LOT 9 OF CLAREMONT BUSINESS PARK FIL NO. 2

EL PASO COUNTY, STATE OF COLORADO
UTILITY SERVICE PLAN

EL PASO COUNTY, STATE OF COLORADO GRADING & EROSION CONTROL PLAN

GRADING & EROSION CONTROL PLAN
LOT 9, CBP 2
JOB NO. 44-030
DATE PREPARED: JANUARY 25, 2018
DATE REVISED:

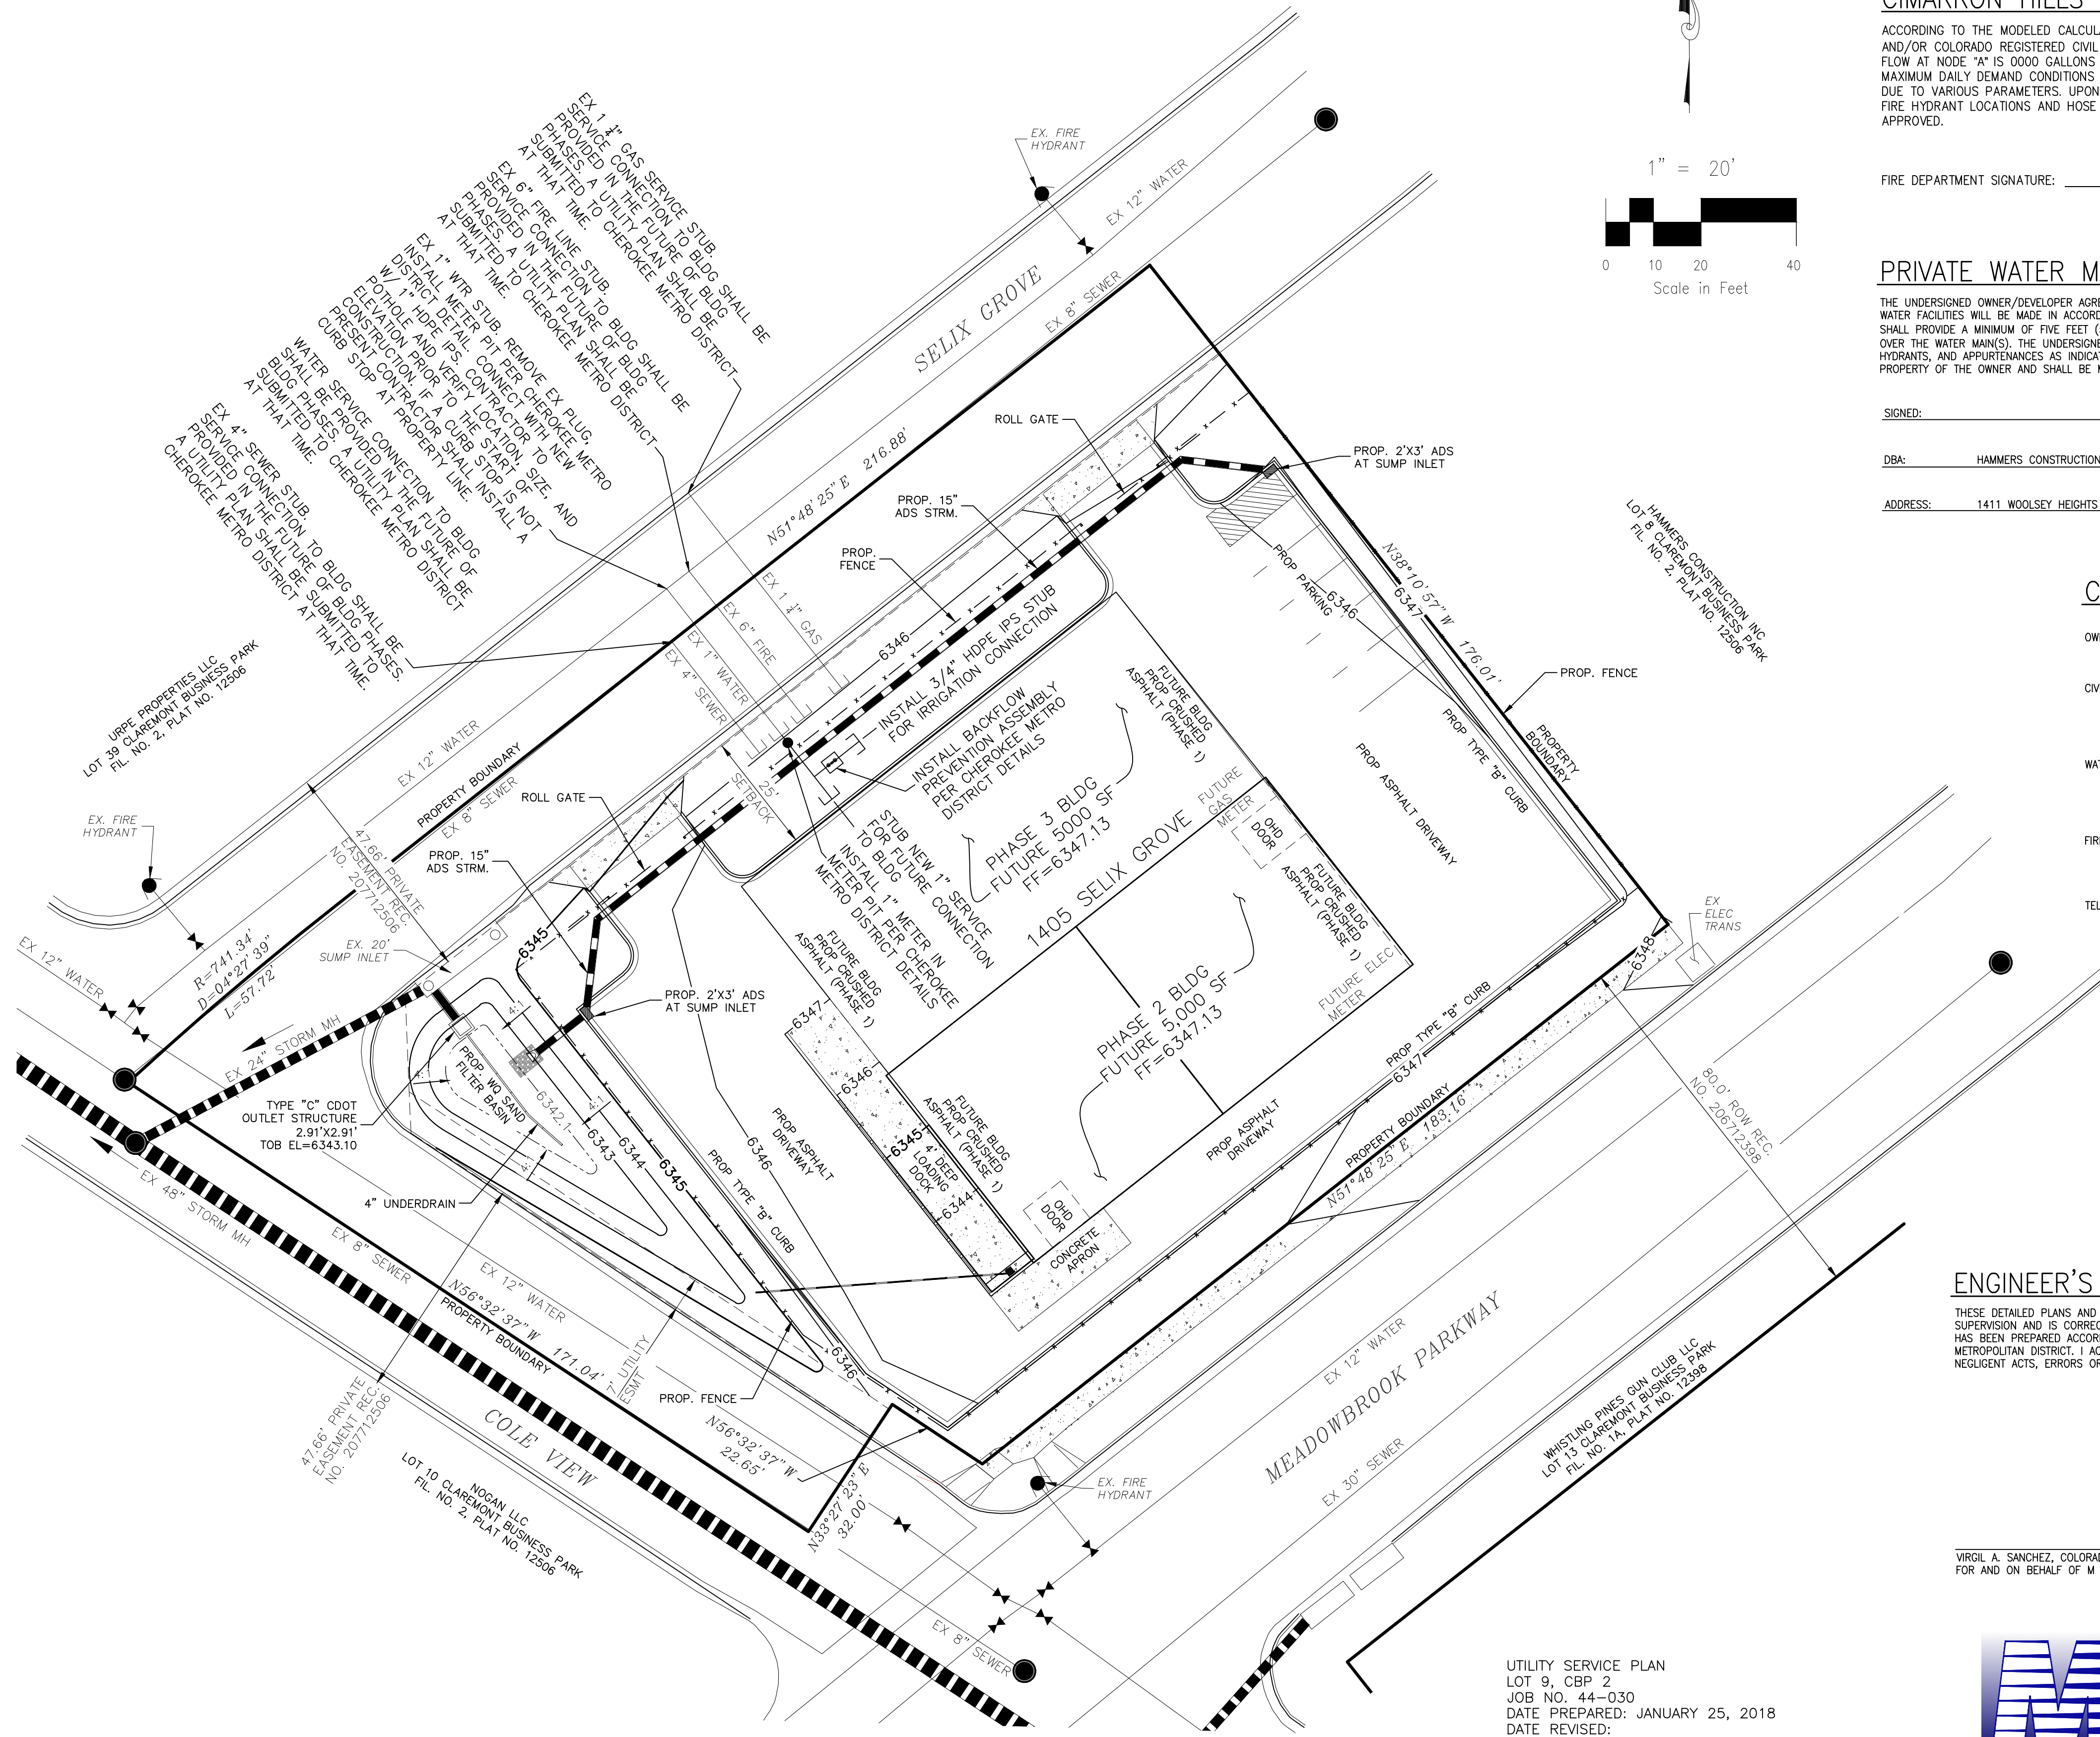
Remove this sheet from the standalone GEC Plan set

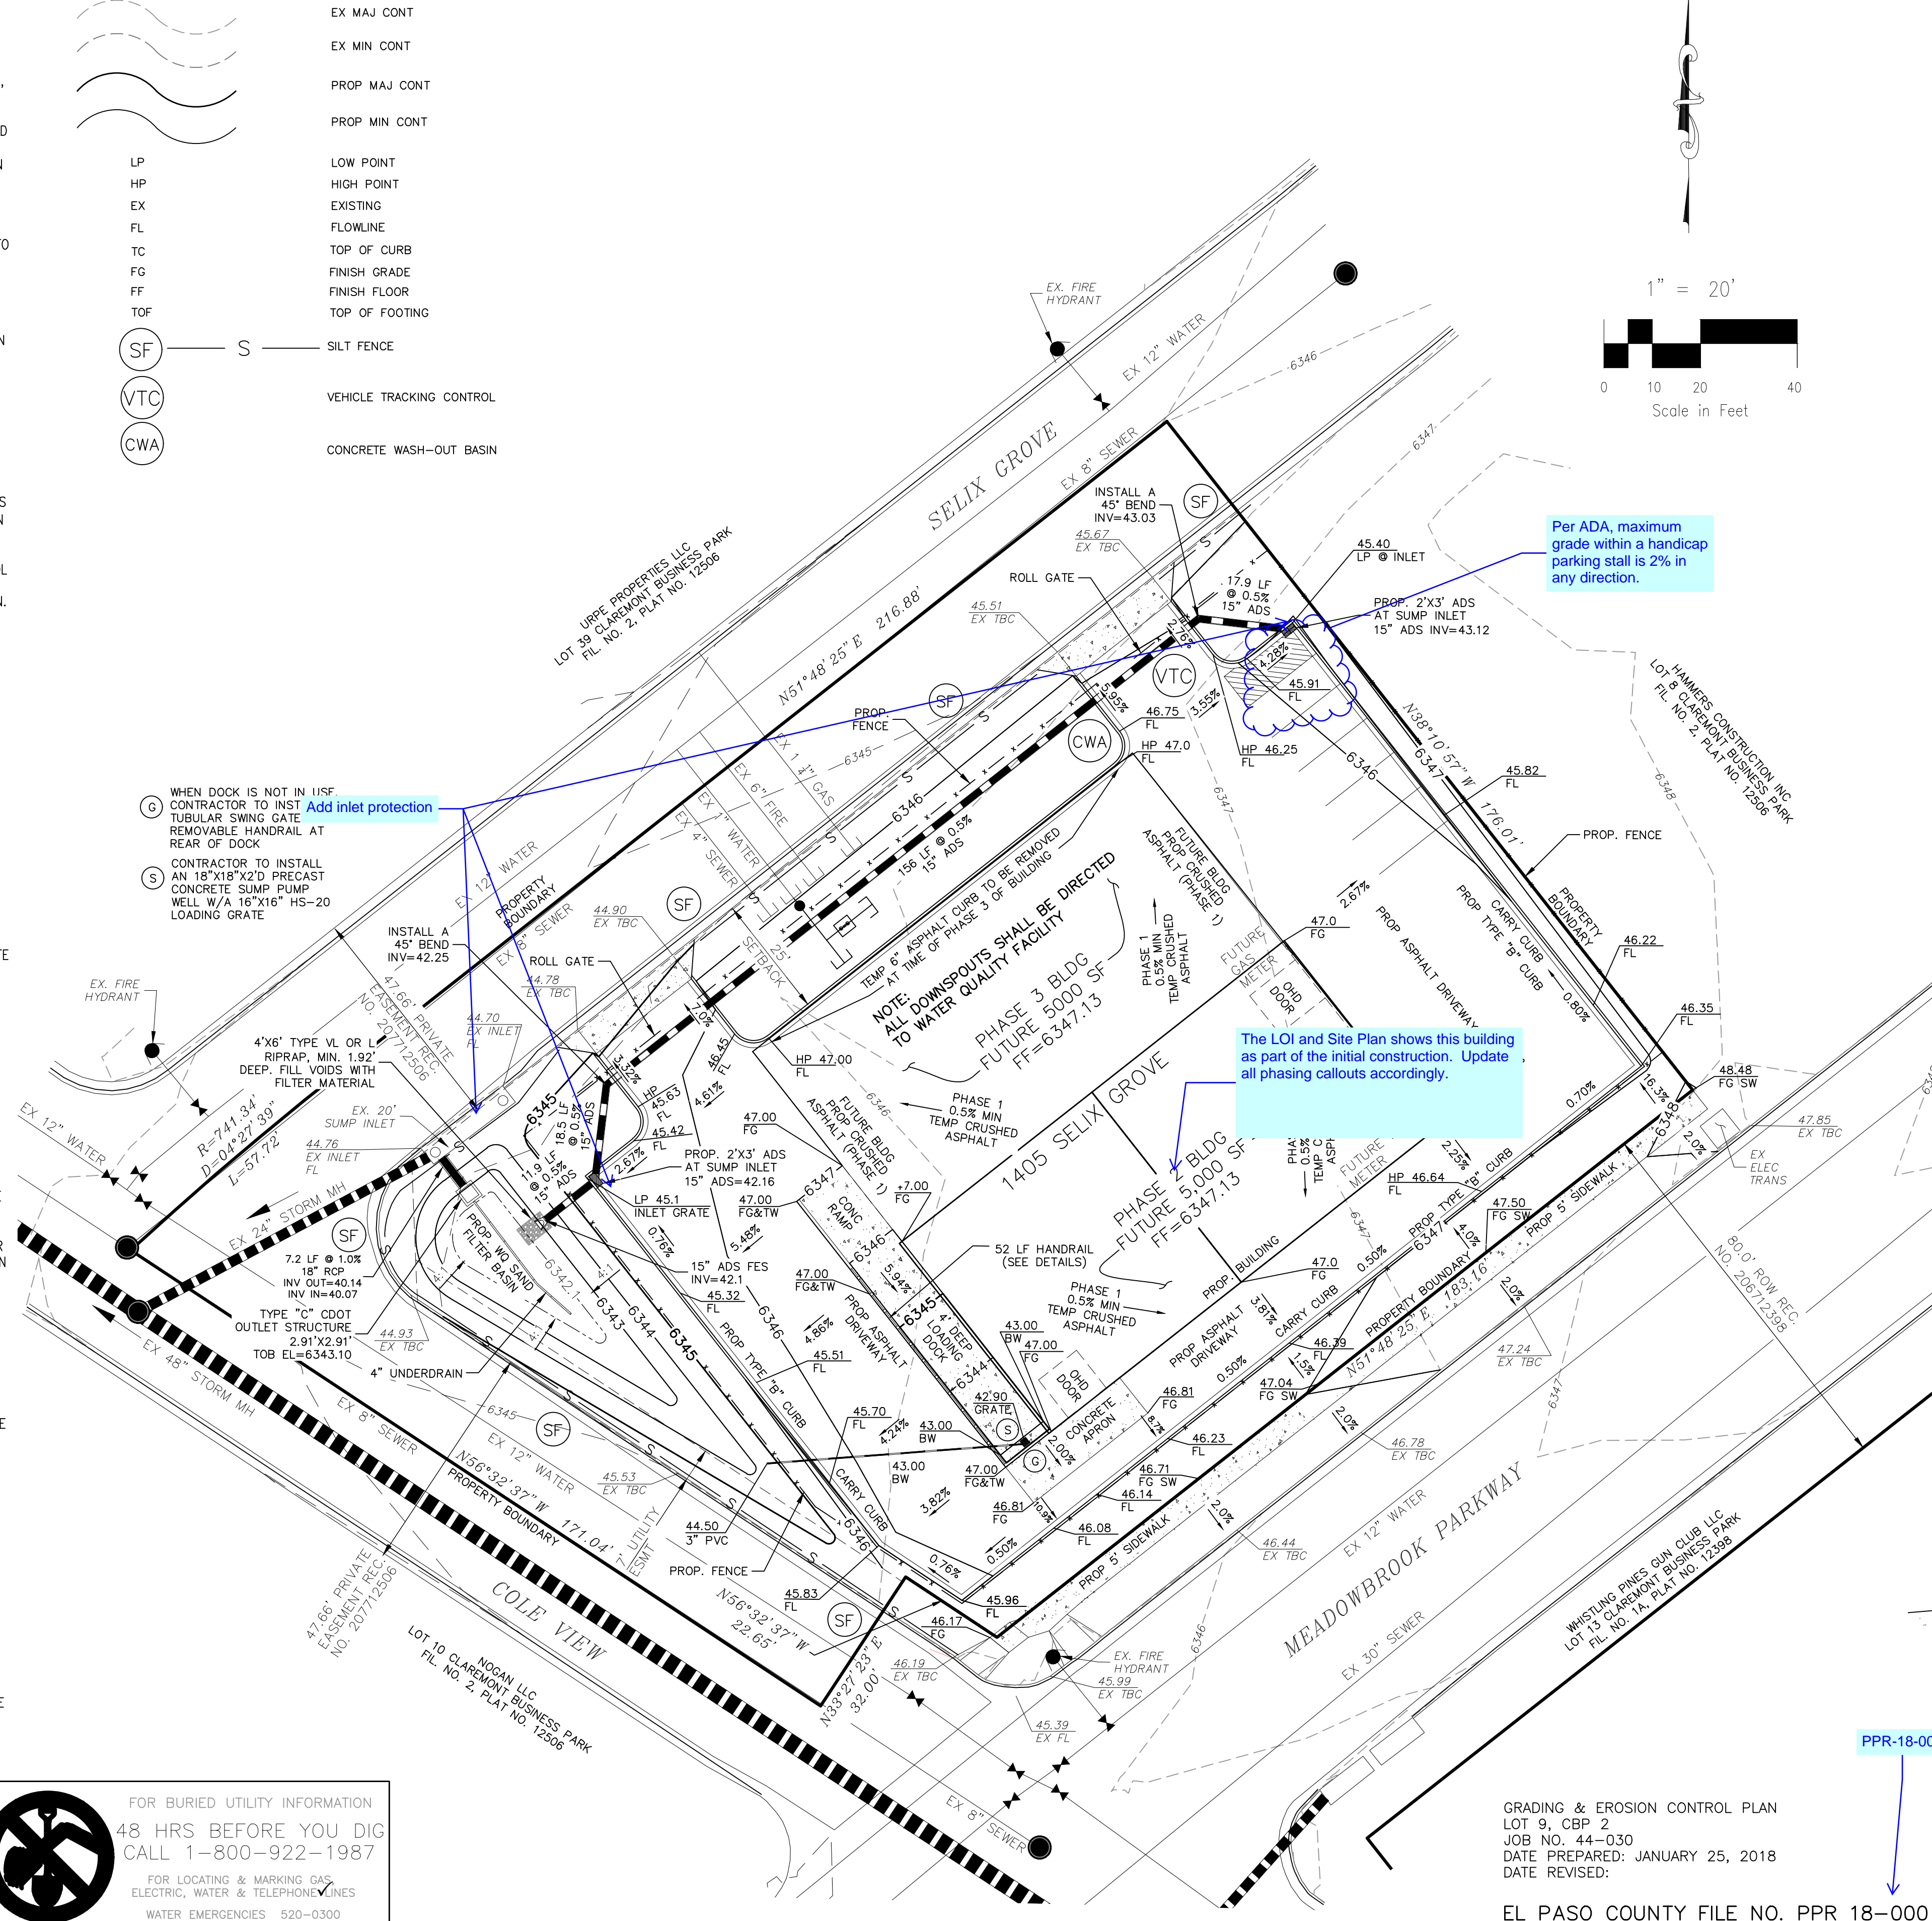
This is a standalone Grading and Erosion Control Plan set; therefore, add sheet index and POC on this sheet.

Per ADA, maximum grade within a handicap parking stall is 2% in any direction.

The LOI and Site Plan shows this building as part of the initial construction. Update all phasing callouts accordingly.
